CITY OF ALBUQUERQUE

May 6, 2022

**Re: Chick-fil-A Central & Eubank/ Remodel
210 Eubank Blvd. SE
Traffic Circulation Layout
Architect's Stamp xx-xx-xx (L21-D045B)**

1229-C-2.0-UTILITY PLAN

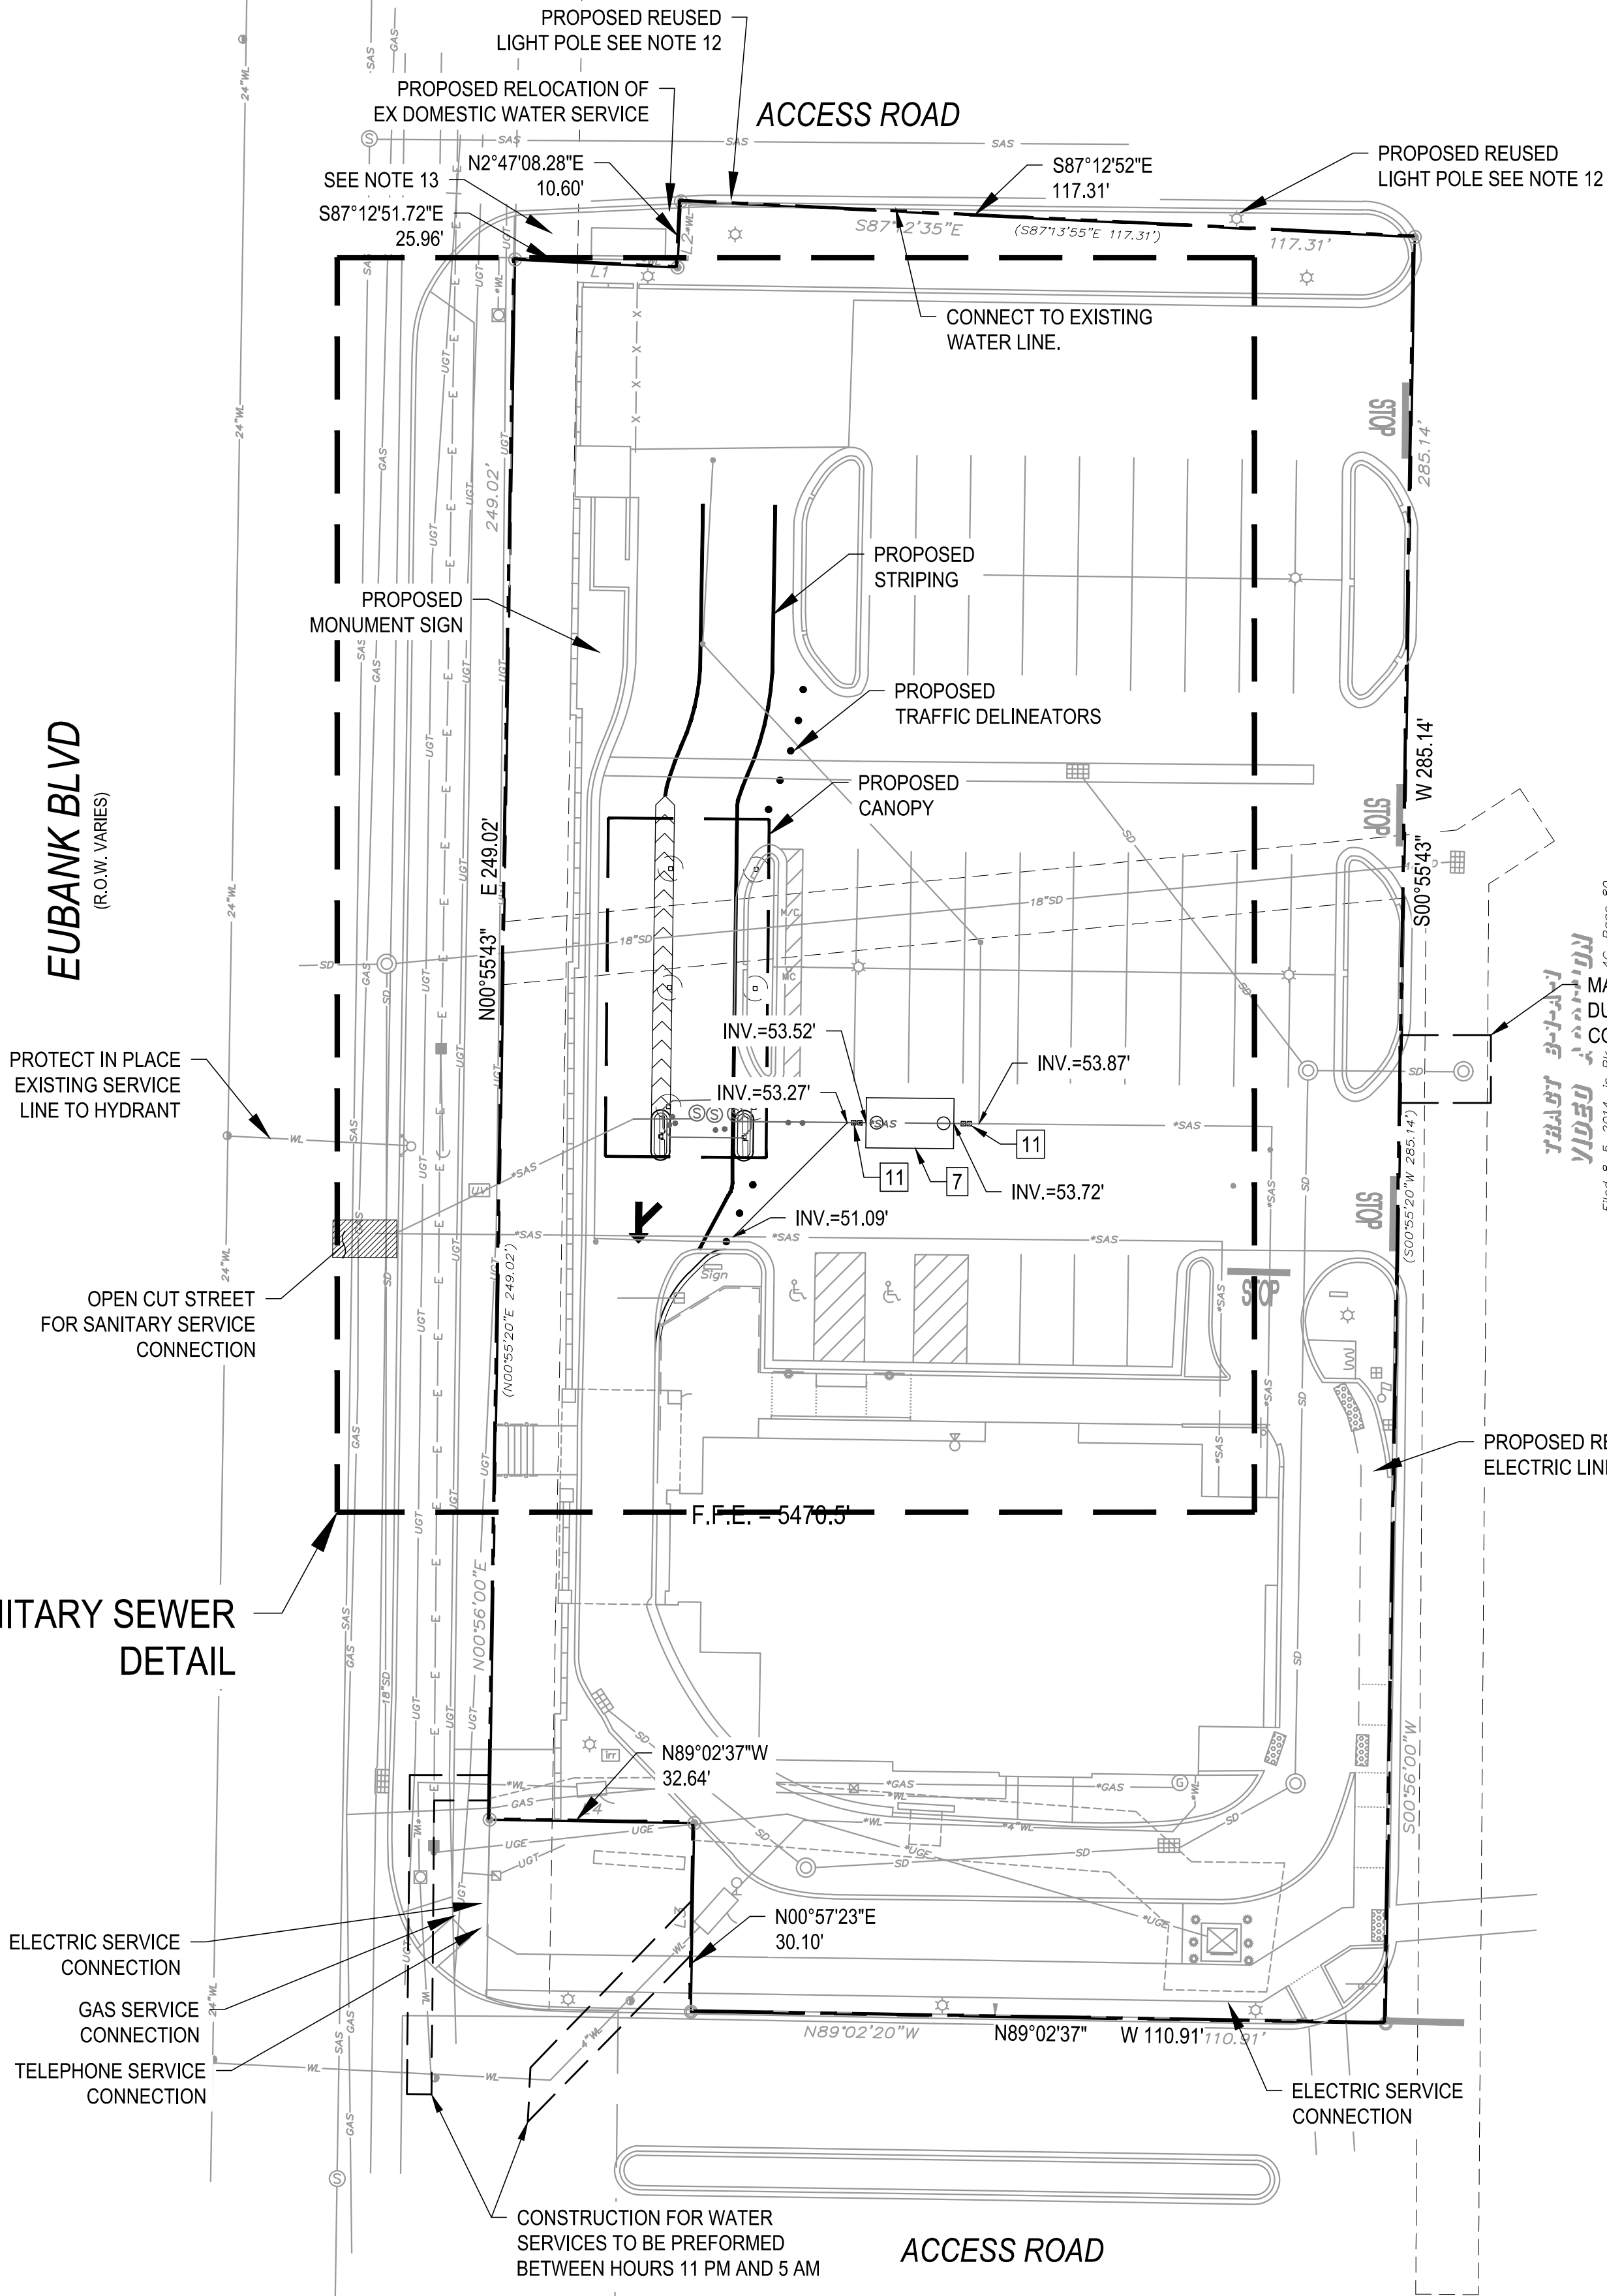
1. The traffic circulation layout must be stamped, signed, and dated by an engineer or architect licensed in the state of New Mexico.
2. Define the property line.
3. Provide drive-thru lanes width.
4. The minimum drive through lane width is 12 feet with a 25 foot minimum radius (inside edge) for all turns. (A 15 foot radius can be used with an increase in lane width to 14 feet). Please dimension all lane widths and radii.
5. Paint proposed striping with white.
6. Key note 7: provide the height for the proposed Precast Grease Interceptor. To make sure it will be drivable surface.
7. Please provide a letter of response for all comments given.
